## River Bend Station - Unit 1 Docket No. 50-458

## ATTACHMENT 1

## Response to Verbal Request for Additional Information

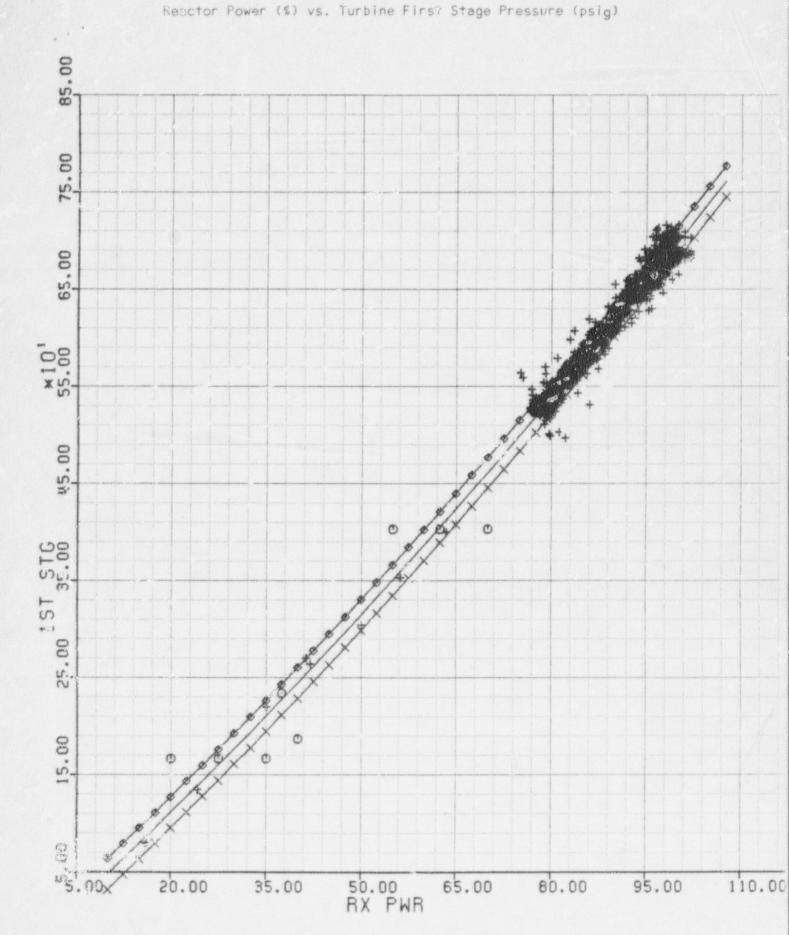
Provide the assumptions used in determining the proposed change to the high power setpoint.

As stated above, the effect of FWHOS operation was not considered in establishing the proposed change to the high power setpoint. As stated in GSU's amendment request, the high power setpoint analytical limit of 70% of RTP was established from the rod withdrawal error analysis presented in Updated Safety Analysis Report (USAR) Section 15.4.2.3.3. The high power setpoint provides an input to the rod withdrawal limiter to initiate more restrictive control rod movement constraints (1 foot vs. 2 foot withdrawal) at reactor power greater than 70% of RTP. There is no safety basis for a lower bound on the high power setpoint.

The proposed Technical Specification allowable value (AV) and nominal trip setpoint (NTSP) were calculated by subtracting uncertainty components from the analytical limit of 70% of RTP (461.2 psig from the measured plant data) as follows:

The AV was calculated by subtracting uncertainties due to measurement accuracies. These include process measurement accuracy, instrument loop accuracy and calibration accuracy. The magnitudes assumed for these uncertainties are provided below. The components of uncertainty were assumed to be independent and normally distributed and therefore, could be combined using the square root of the sum of the squares (SRSS) method. The appropriate statistical allowance which yields a 95% probability of trip actuation (2**c**) was used.

The NTSP was calculated by subtracting the uncertainty due to instrument channel drift from the AV. The drift was also assumed to be independent and normally distributed and was therefore, also subtracted using the SRSS method.

The magnitudes assumed for the uncertainties used in calculating the AV and NTSP are:

Process measurement accuracy = 12.8 psig

- 2. Instrument loop accuracy = 10 psig
- 3. Calibration accuracy = 3 psig
- 4. Drift accuracy = 10 psig.

The results of this calculation correspond to the proposed Technical Specification high power setpoint AV and NTSP provided in GSU's amendment request.

The in-plant setpoint for the high power setpoint was then determined by subtracting the FWHOS effect on TFSP (39 psia) from the above AV and NTSP. An additional uncertainty was included (6.4 psia) to account for heat balance modeling. This will therefore ensure that the in-plant setpoint will be less than that proposed in GSU's amendment request, even with a rated power feedwater temperature of 320 degrees F.
